# **A Defense-in-Depth and Diversity Assessment of the GE ABWR Protection System**

December 17, 1991  
Version 2

Lawrence Livermore National Laboratory  
Nuclear Systems Safety Program

General Electric Corporation has submitted design information for the Advanced Boiling Water Reactor (ABWR) to the Nuclear Regulatory Commission for certification under 10CFR Part 52, Subpart B. The purpose of this report is to identify potential vulnerabilities with regard to defense-in-depth provided in the proposed ABWR protection system design which is part of that submittal (SAR Chapter 7). This analysis provides a detailed assessment of diversity and defense-in-depth for this design.

**Figure 3** Echelon diagram showing possible interactions (dotted) and shared signals.

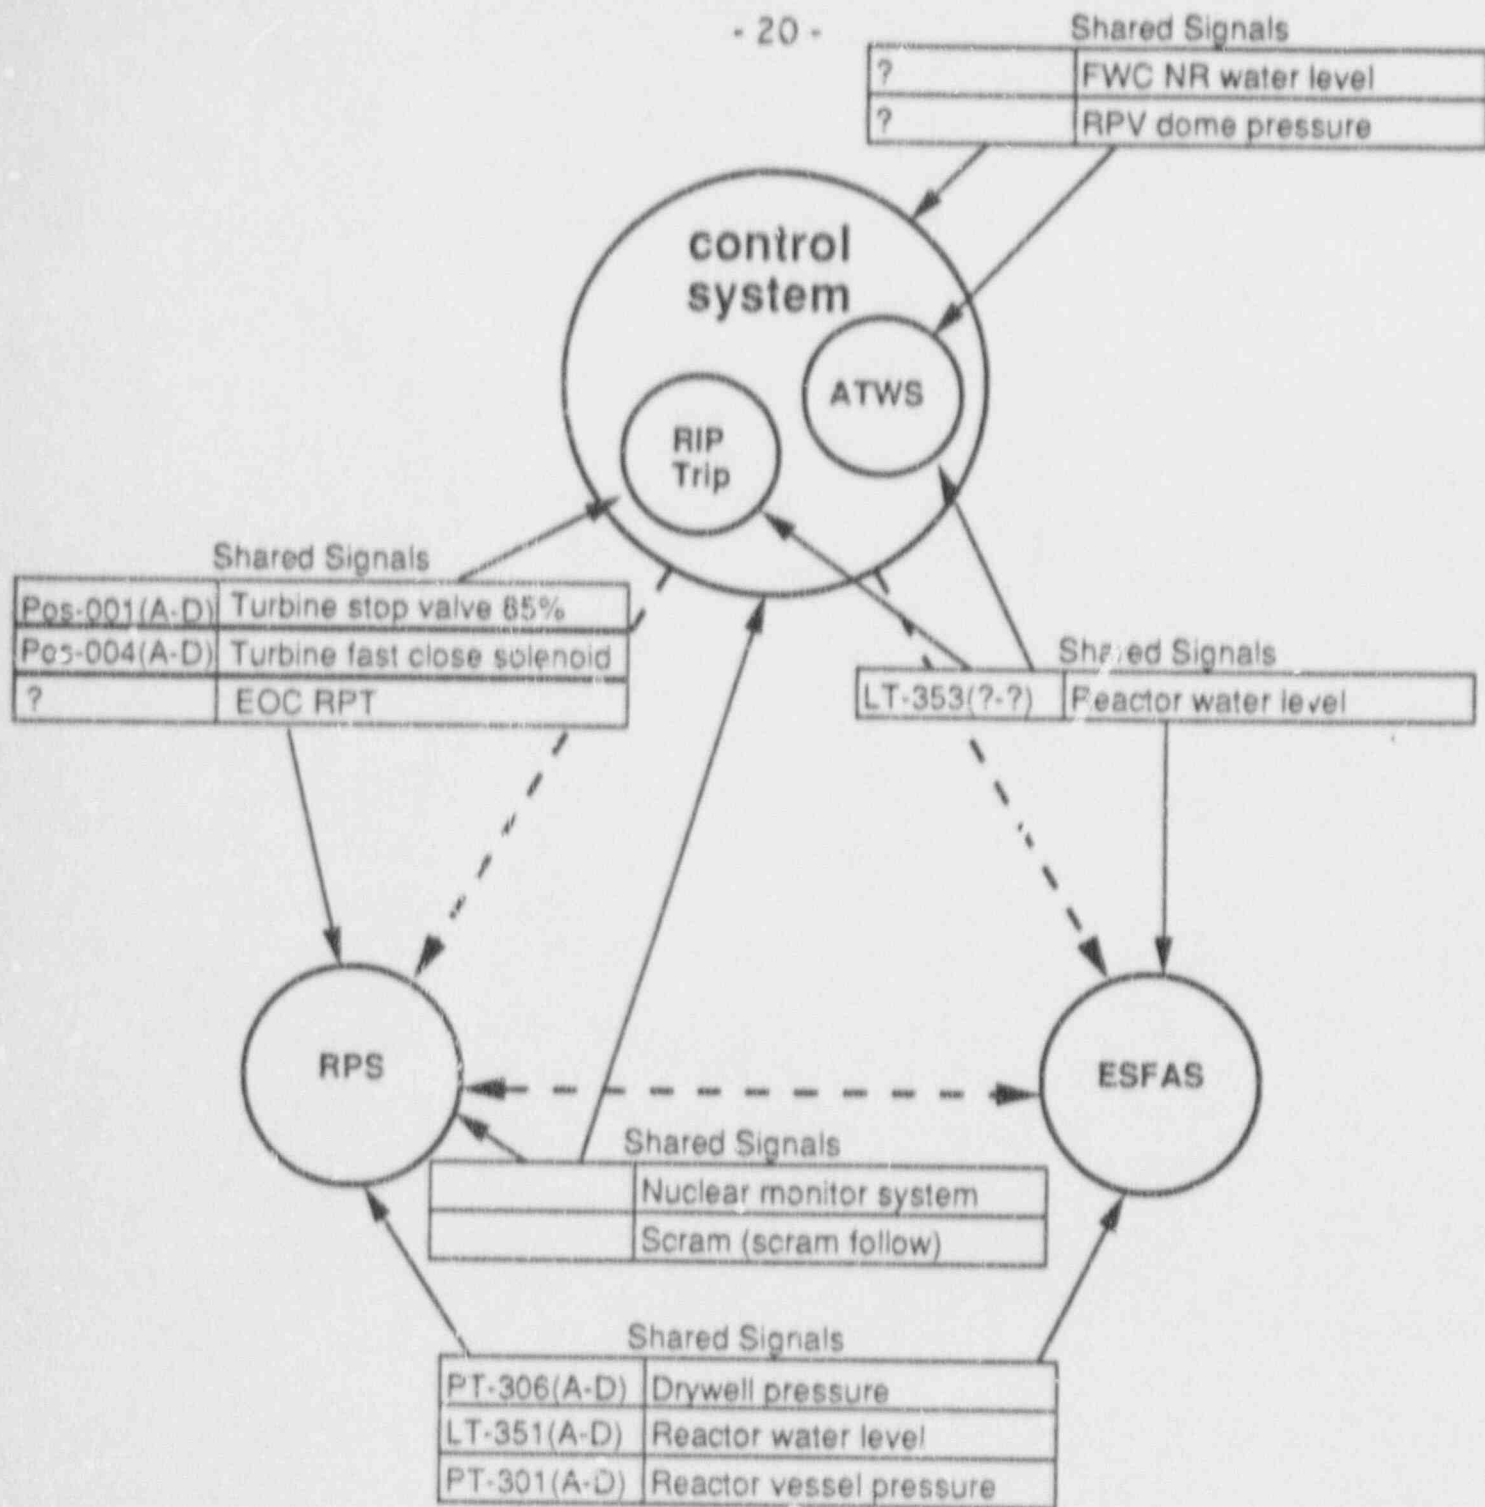
the control system. A diverse method for scrambling the reactor, anticipated-trip-without-scam (ATWS), is being implemented as part of the control system. For the most part, these echelons are separate. However, some signals are shared between echelons, and this is shown in Figure 3 with ATWS and RIP trip being made explicit.

Figure 8 GE ABWR I & C System Architecture  
Showing LT 353 signal path  
Note:  
1. Interdivision connections not shown.

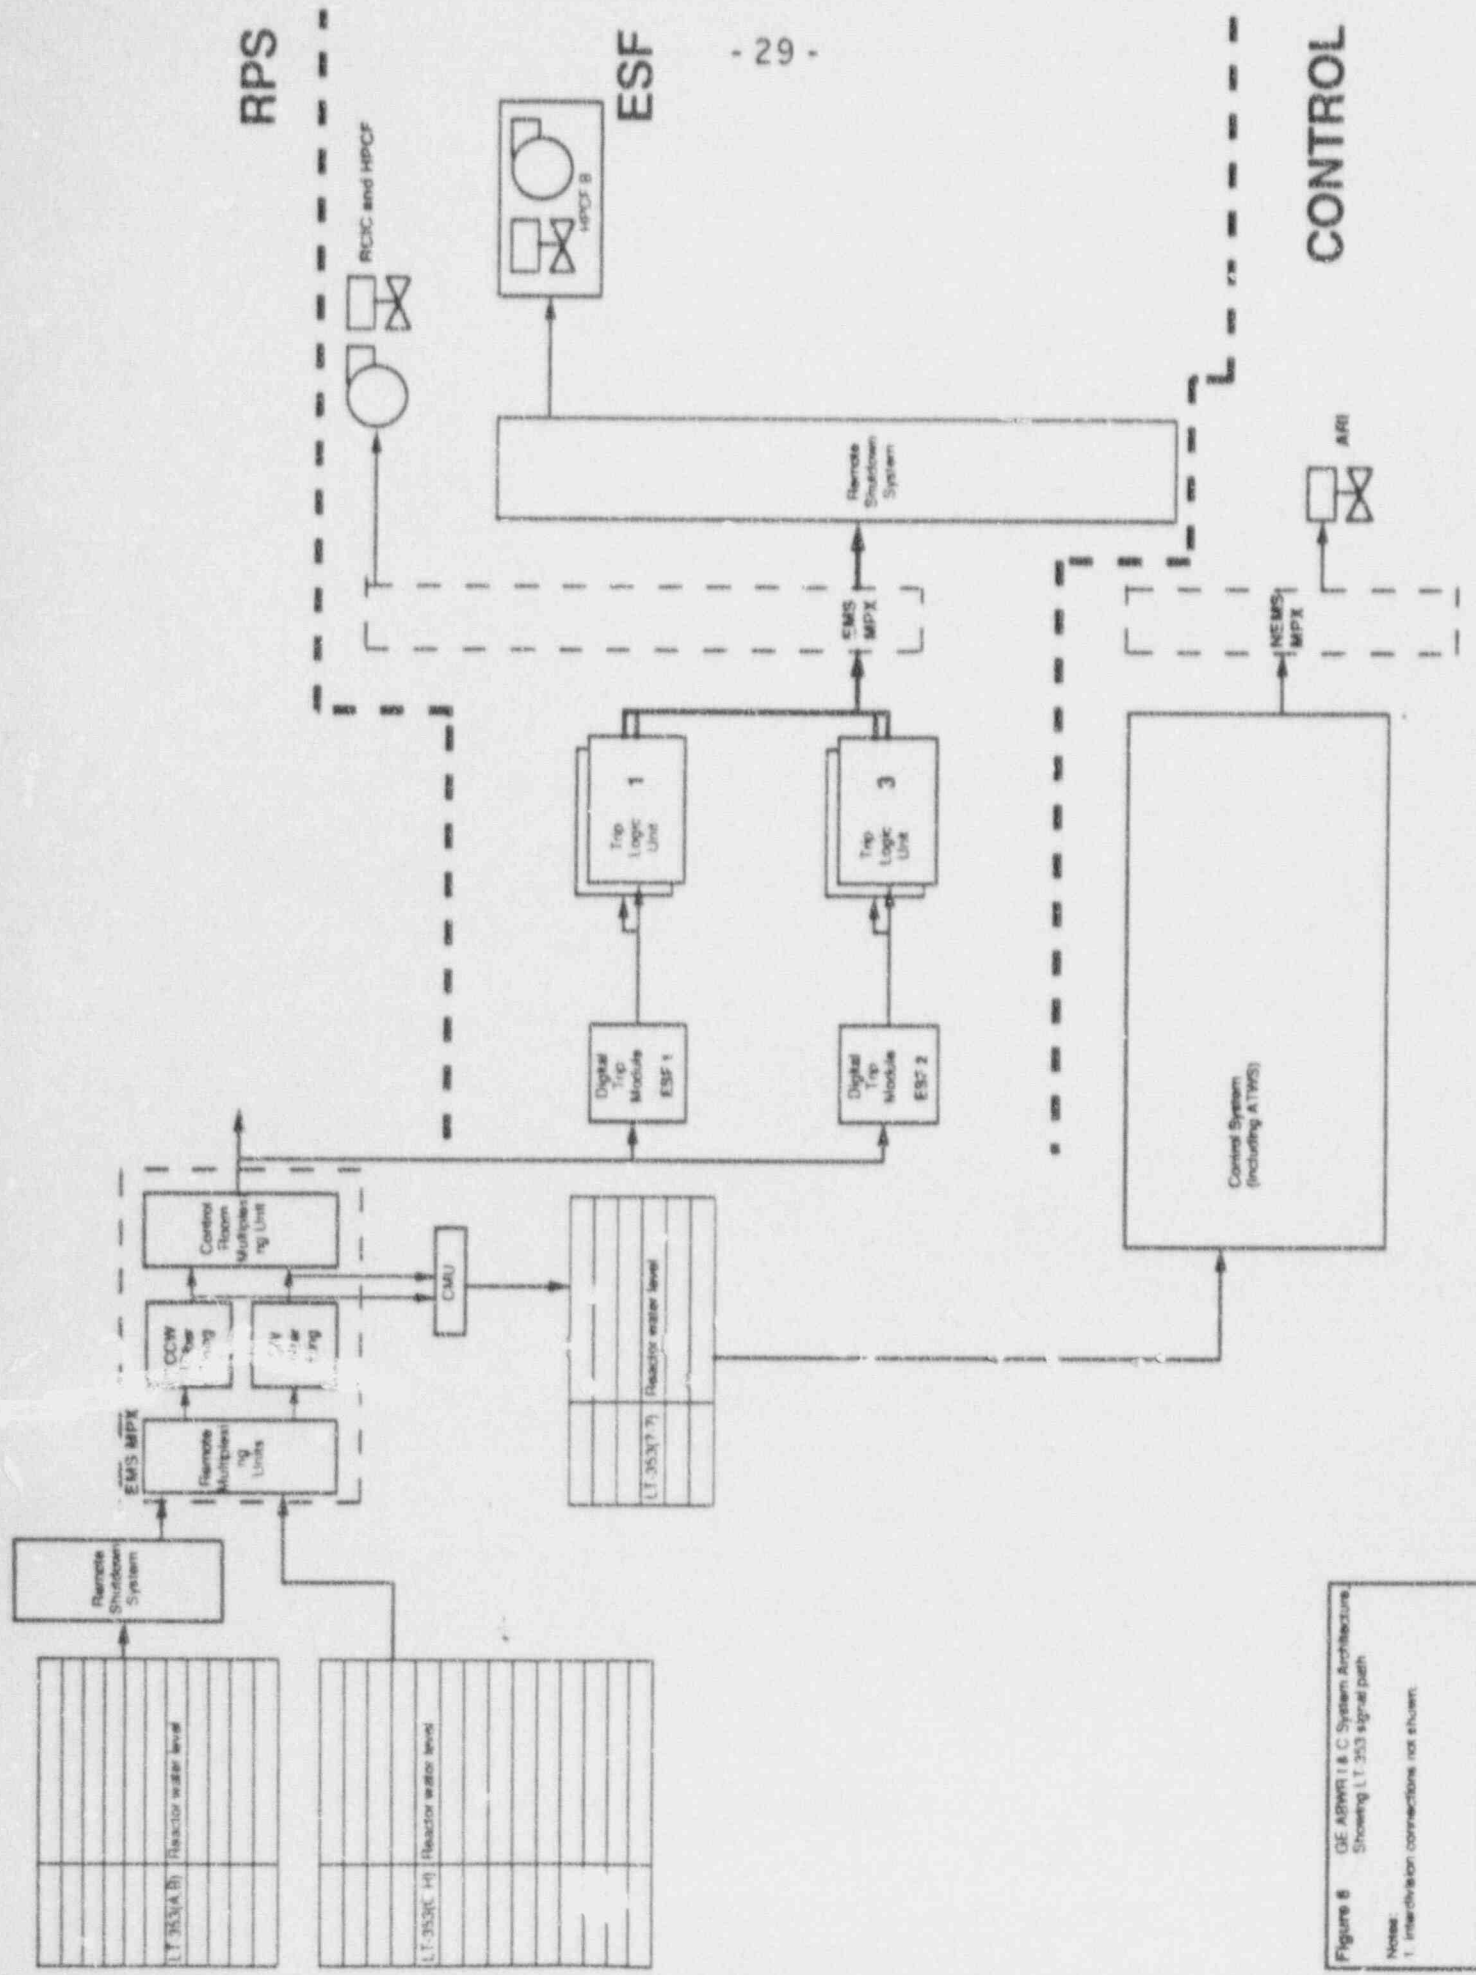
echelons (compare with echelon diagram Figure 3). Signal flow is demonstrated in Figure 6 (the LT-353 signal that passes through the EMS) and in Figure 7 (turbine switches that enter the RPS DTM and are passed to the control system through an optical isolator).

This is a set of four narrow-range water level transmitters used for several functions. The functions of most interest are those of low-water-level scram and high-water-level shutoff of the RCIC and HPCF. For RCIC it shuts down the whole system including the turbine. For HPCF it closes the injection valve. Thus these transmitters cross the RPS and ESFAS echelons (Figure 9). If this transmitter or its associated signal channel should stick in the high-water-level state (>L8) the reactor would not scram on its normal low-water-level condition, RCIC would not initiate, and although the HPCF pumps would start, the HPCF injection valve would not open. This can all be seen from the IBDs included in Chapter 7. Once the water level gets low enough, the MSLIVs will close and a diverse reactor trip will be initiated when the MSLIVs are at 85% open.

**Figure 9** Echelon diagram showing shared signals which are vulnerable to causing multiple failures either by induced transient (fault type 1) or by latent fault (fault type 2).

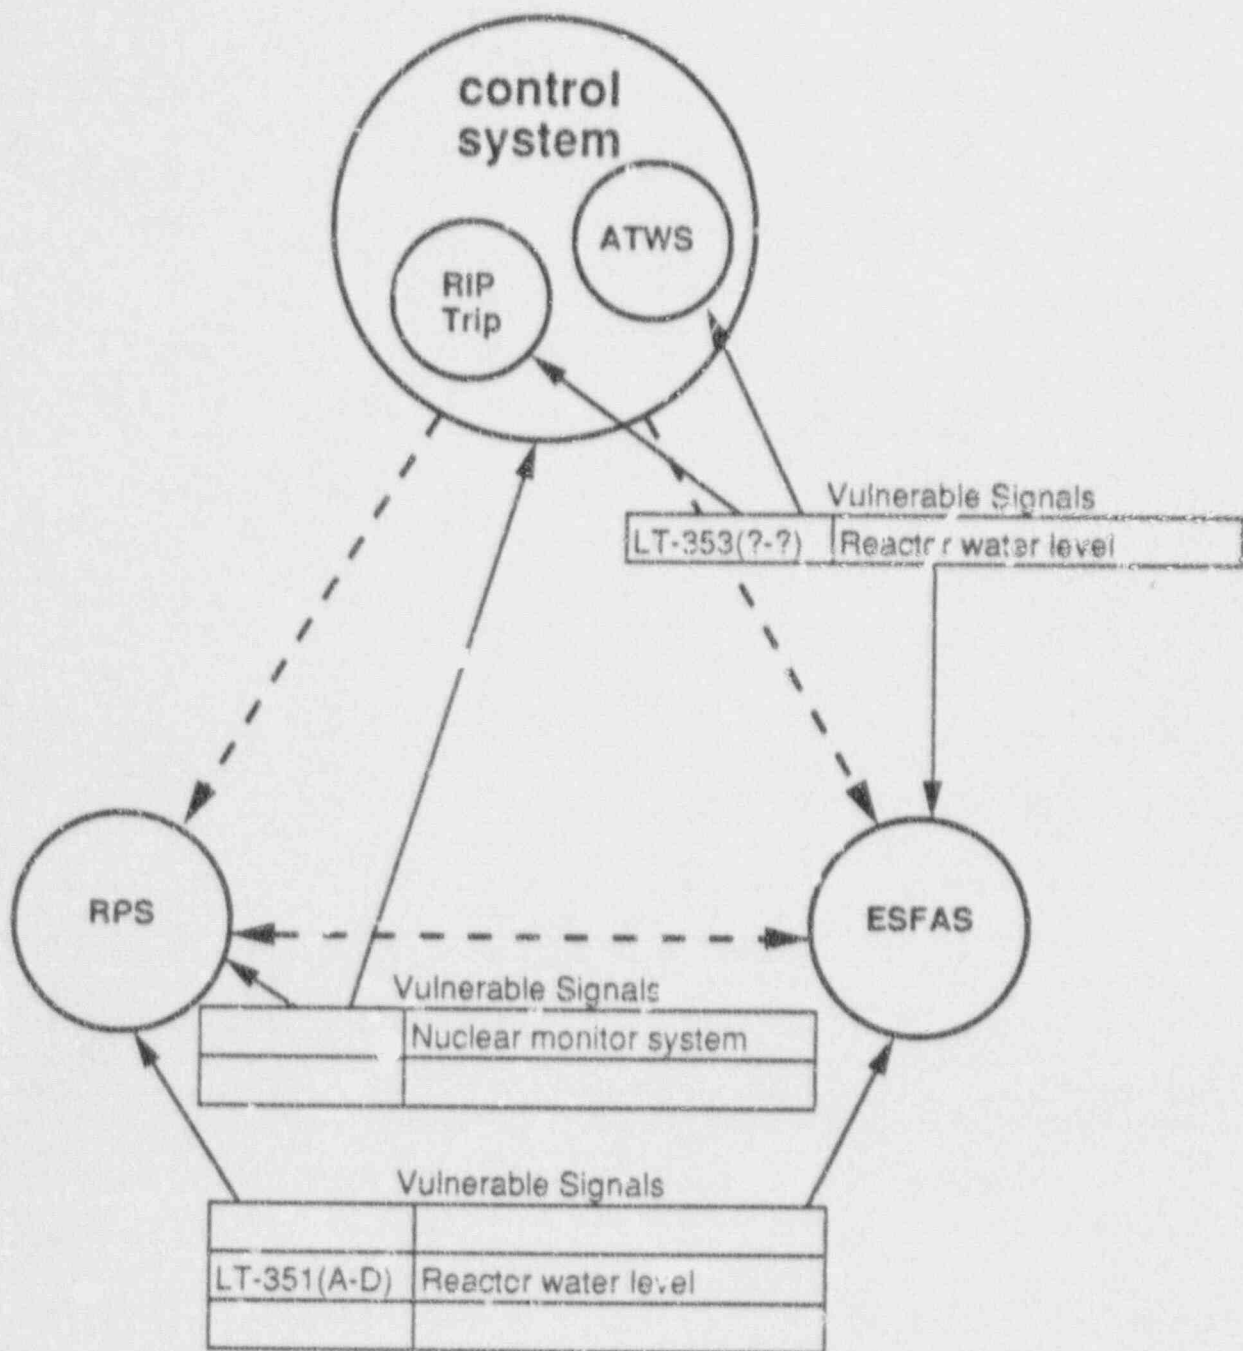
The APRM produces a high flux scram for the RPS, provides information on which rod-block determinations are made by the control system, provides neutron flux level used for automatic load following by the rod control system, and provides neutron flux level information for use by operators. Thus it links the control, manual control and RPS echelons (Figure 9). A failure of the APRM could prevent a rod-block from occurring (this is not clear from the documentation) while simultaneously preventing a high-flux scram from occurring. Under-reporting neutron flux levels by the APRM has the potential for inducing high flux operation of the reactor either by automatic (Guideline 8) or manual control (Guideline 9) while preventing a high-flux scram. This is a vulnerability that should be examined carefully.

The multiplexer in this system links all three echelons. It carries low-water-level data and rod-separation information to the control system to initiate ARI and rod-block. It carries a large number of signals to both ESFAS and RPS. (Some RPS signals are wired directly to either the DTM or TLU of the RPS.) This linkage could cause unacceptable failures by preventing scram when needed and simultaneously preventing ARI and the initiation of ECCS. (SLCS may be affected by this linkage, but there is no information on how SLCS is initiated automatically. It is stated in section 3.3.5.2 of the SAR that SLCS can be manually initiated.)

**Figure 10** Echelon diagram showing shared water level signal (in control system) which may result in persistent high reactor water level. RPS will not scram because linkage is through turbine stop valve switches.

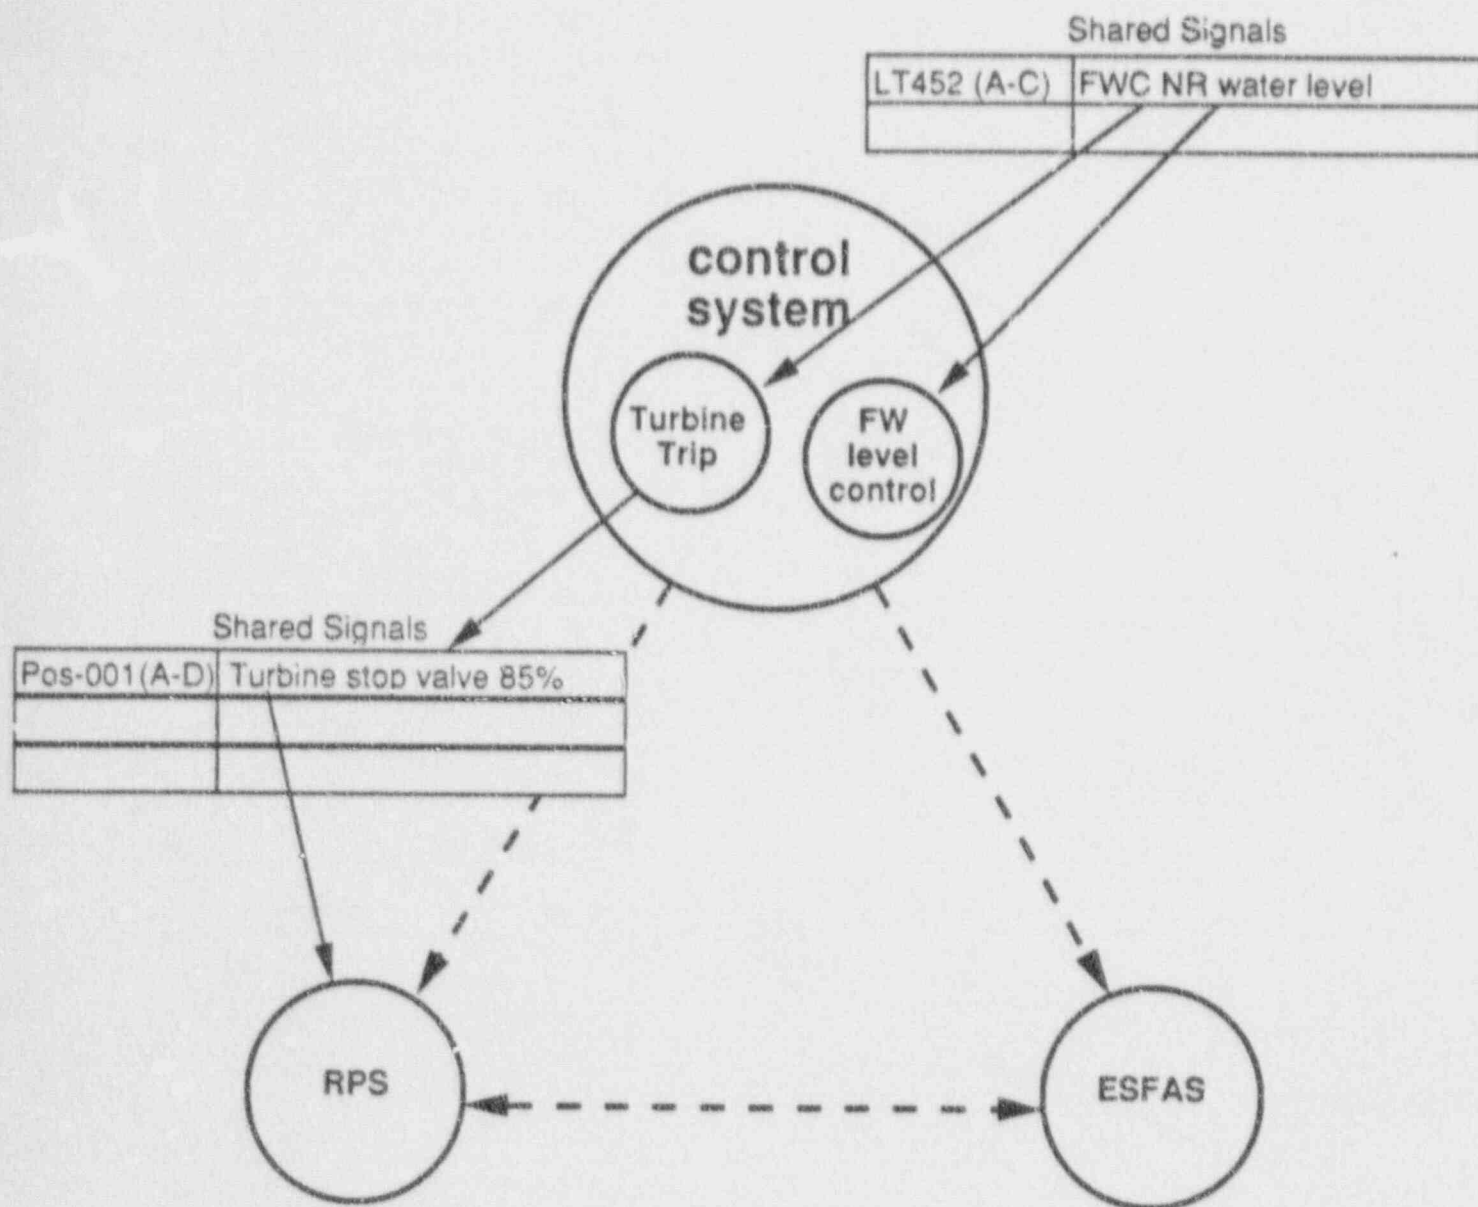
In the control system, the same water level sensors which are used to control feedwater flow are also used to initiate high-water turbine trip. Thus a failure which could induce an off-normal condition also inhibits corrective action. The RPS does not trip on high water level but does scram on turbine stop valve closure, which in this case will not occur (Figure 10). Although high water level is not an immediate danger to the reactor, the potential exists for this condition to remain for extended periods of time. It may be appropriate to review the effects of lengthy uncontrolled reactor high water level.
